LAND AT CRAWLEY ROAD, FAYGATE
RESIDENTIAL DEVELOPMENT

STAGE 1 ROAD SAFETY AUDIT
RESPONSE REPORT

REVISED STAGE 1 ROAD SAFETY AUDIT

Drawing Number
SK21905-09 REV A

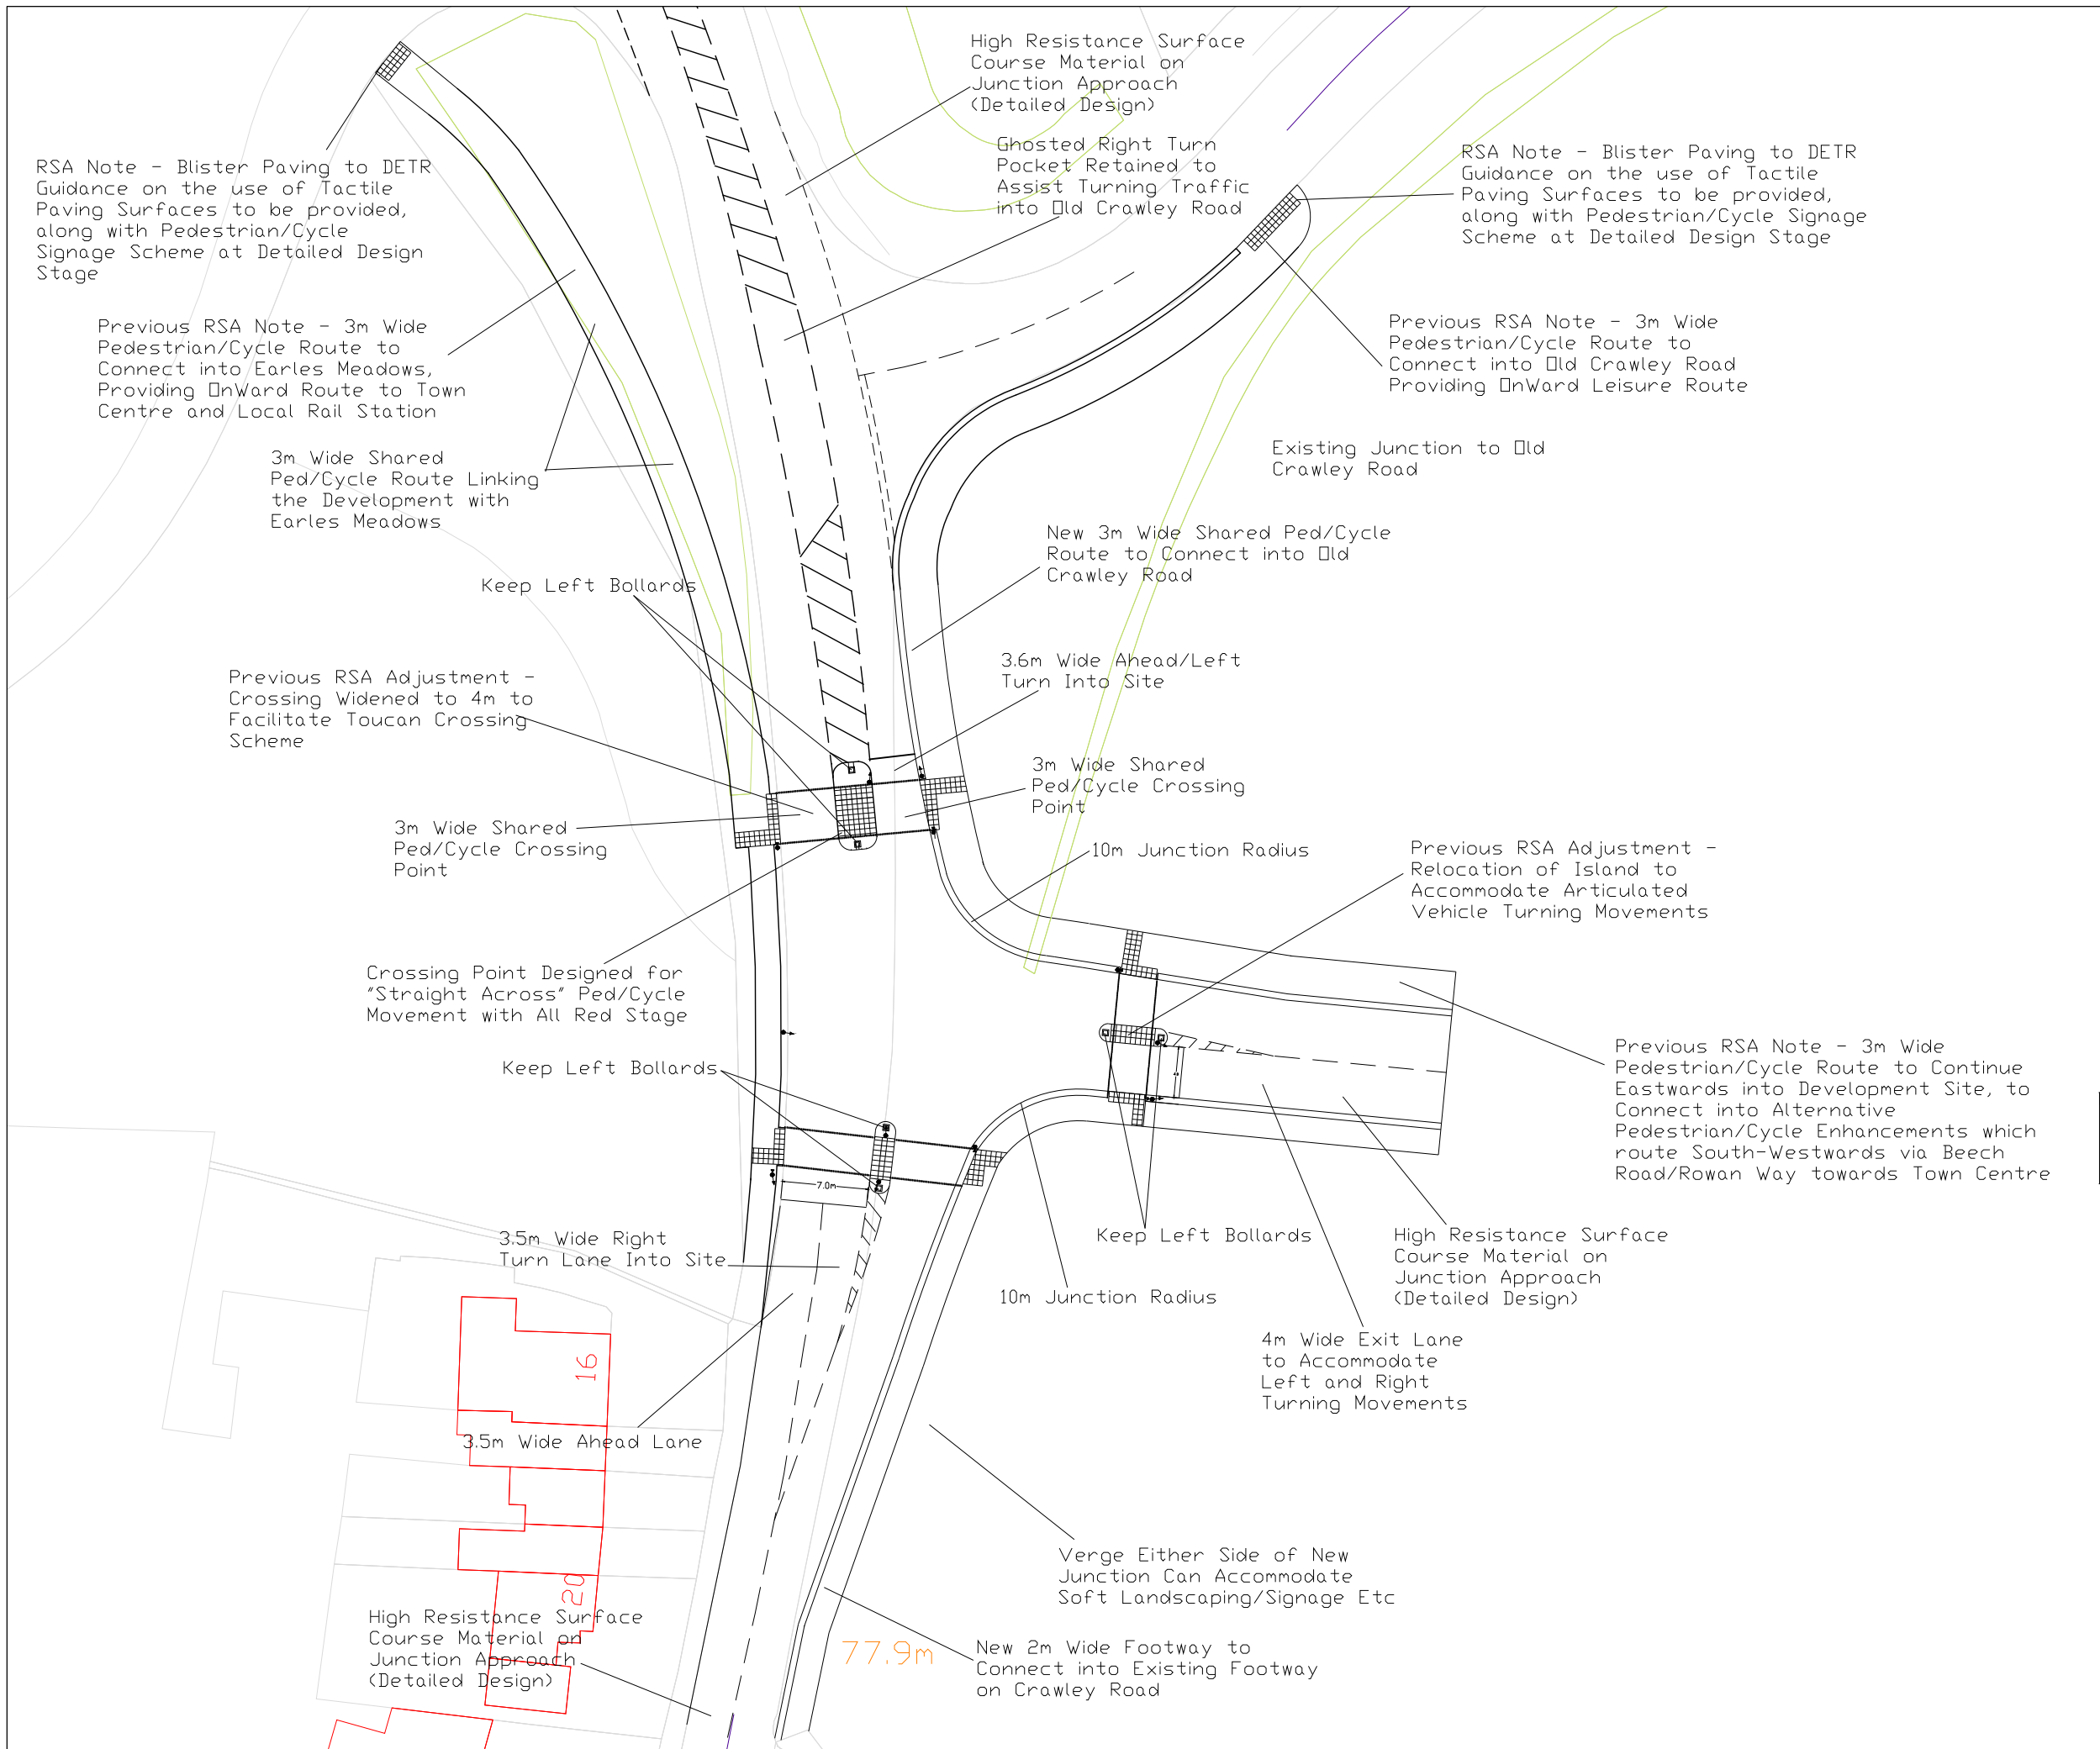
- 2.5 The RSA team have commented that they have a concern that any larger vehicles turning right into the development site access from Crawley Road (the southern junction arm) into the development site (the eastern arm) would encroach into the adjacent northbound traffic lane when undertaking this turning manoeuvre.

- 2.6 The audit team has raised the concern that this could lead to a potential increased risk of side swipe type vehicle collisions occurring between larger vehicles turning right from the southern arm of Crawley Road and another large vehicle travelling northbound towards the A264 corridor.

Concern arises that this situation could lead to a potential increased risk of side swipe type vehicular collisions occurring between larger vehicles turning right from Crawley Road (southern arm) into the development site (eastern arm), and other larger vehicles such as a bus travelling northbound on Crawley Road, whereby vehicle occupants could sustain personal injury.

- 2.9 A review of the width of the nearside "ahead" lane confirms that at the stop line if the refuse vehicle was making a right turn manoeuvre the useable nearside lane width would be 3.21m, increasing to 3.67m immediately to the north of the controlled crossing facility. This width increases to 4.95m at a point where the refuse vehicle is undertaking its right turn into the site.

- 2.10 These measurements are shown on plan in **appendix b**, and are considered to be a "worst case" assessment, with the refuse vehicle positioned 0.7m from the central junction refuge, when undertaking this manoeuvre.

- 2.11 Based on this review it is confirmed that there is appropriate width along the northbound nearside "ahead" lane to allow larger vehicles to pass another large vehicle turning right into the development site.
